Access Compliance Report

Public Rights-of-Way

Intersection ID: 26840	Main Street: OLD_COURSE_DR	Cross Street: REA_RD	Location: SW
ADA ID: 62355F6DCB69	Ramp Type: PerpDiag	Initial Pass/Fail: Fail	Overall Compliance: No
		Severity Score: 22.5

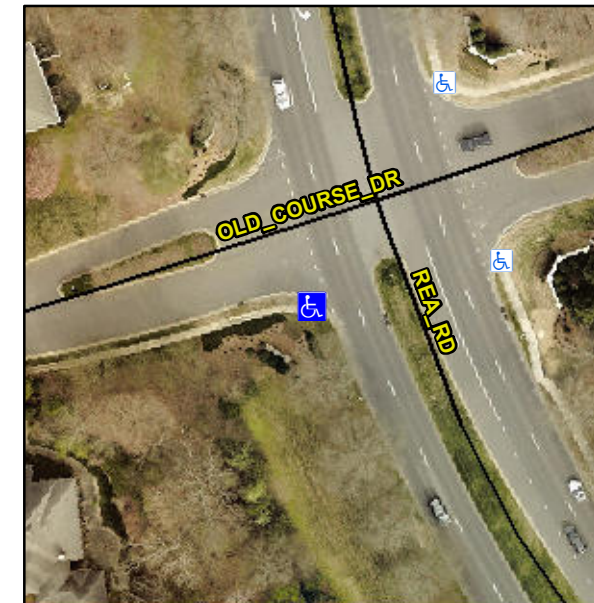
Not Found, R304.5.1, R304.2.2, R304.5.3

Compliance	Description	Data	Compliance	Description	Data
N/A	Ramp Length (in)	96.0	No	Ramp Slope (%)	9.2
No	Ramp Width (in)	37.0	No	Ramp XSlope (%)	3.7
N/A	Flare Type LT	N/A	N/A	Flare Type RT	N/A
N/A	Flare Slope LT (%)	N/A	N/A	Flare Slope RT (%)	N/A
N/A	Flare Traversable LT?	N/A	N/A	Flare Traversable RT?	N/A
N/A	Landing Length (in)	N/A	N/A	DWS Provided?	N/A
N/A	Landing Width (in)	N/A	N/A	DWS Contrast?	N/A
N/A	Landing Slope (%)	N/A	N/A	DWS Length (in)	N/A
N/A	Landing X Slope (%)	N/A	N/A	DWS Full Width?	N/A
N/A	Landing Curb? (Y/N)	N/A	N/A	DWS Offset (in)	N/A
N/A	Shared Landing?	N/A			
N/A	Gutter Ponding?	N/A	N/A	Gutter Slope (%)	N/A
N/A	Gutter Lip Ht (in)	N/A	N/A	Gutter X Slope (%)	N/A
N/A	Painted X Walk1?	No	N/A	Painted X Walk2?	No
	X Walk 1 Direction	To E		X Walk 2 Direction	To N
N/A	X Walk 1 Width (in)	N/A	N/A	X Walk 2 Width (in)	N/A
	X Walk 1 Slope (%)	6.1		X Walk 2 Slope (%)	4.4
	X Walk 1 X Slope (%)	2.5		X Walk 2 X Slope (%)	3.3

Remove & Replace Curb Ramp With Two New Directional Ramps or Equivalent.
